Title: MATERIALS & METALLURGY SUBCOMMITTEE
MEETING (ACRS)

Date: Thursday, November 16, 2000

MATERIALS AND METALLURGY SUBCOMMITTEE MEETING
CALCULATION OF NEUTRON FLUENCE DG-1053

**ADVISORY COMMITTEE ON REACTOR SAFEGUARDS
MATERIALS AND METALLURGY SUBCOMMITTEE
CALCULATION OF NEUTRON FLUENCE DG-1053**

FIGURE 4

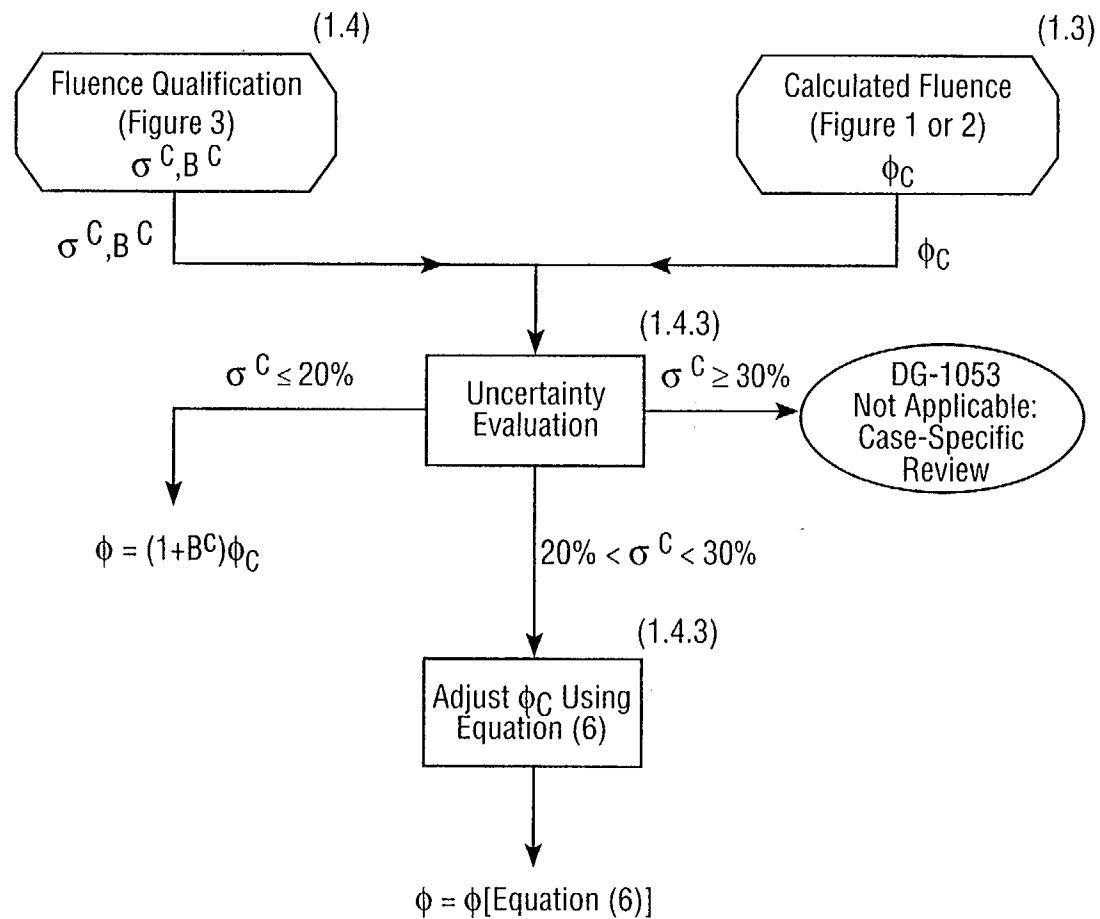
8 DR. CAREW: Okay. I have one more comment, and
9 this was the comment from Bechtel Power, Bill Hopkins. And
10 his comment was that he suggested the attached figure should
11 be included in the guide to clarify the dependence of the
12 fluence determination on fluence uncertainty. And we
13 thought that was a good suggestion and we have incorporated
14 that figure as Figure 4 in the guide.

Comments	Responses
2) <u>Comment:</u> The attached figure should be included in the Guide to clarify the dependence of the fluence determination on the fluence uncertainty.	2) <u>Response:</u> The proposed figure provides a significant clarification of the procedure used to determine the fluence and will be included (as Figure-4) in the Guide.
